Access Compliance Report Public Rights-of-Way (Curb Ramps)

Main Street: KEMPTON_DR Cross Street: FOSTER_RD Location: SE

ADA ID: RPRK211221124159 Ramp Type: Type 1 - Perpendicular Diagonal Initial Pass/Fail: Pass Overall Compliance: No Severity Score: 4

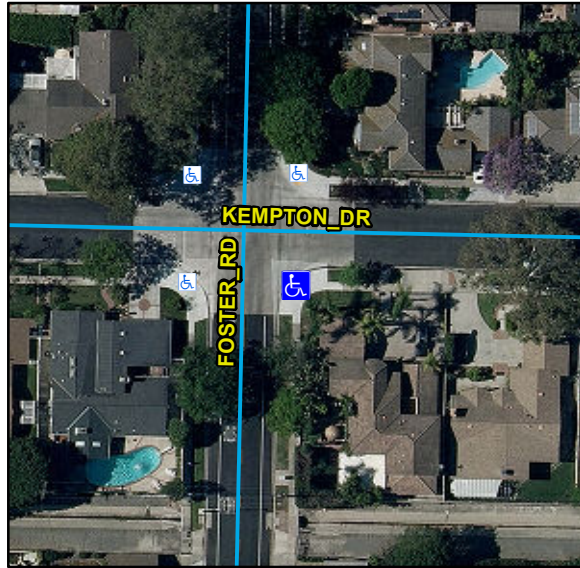
Remove & Replace Curb Ramp With Two New Directional Ramps or Equivalent.

R304.2.2, R304.2.1, STD 1115
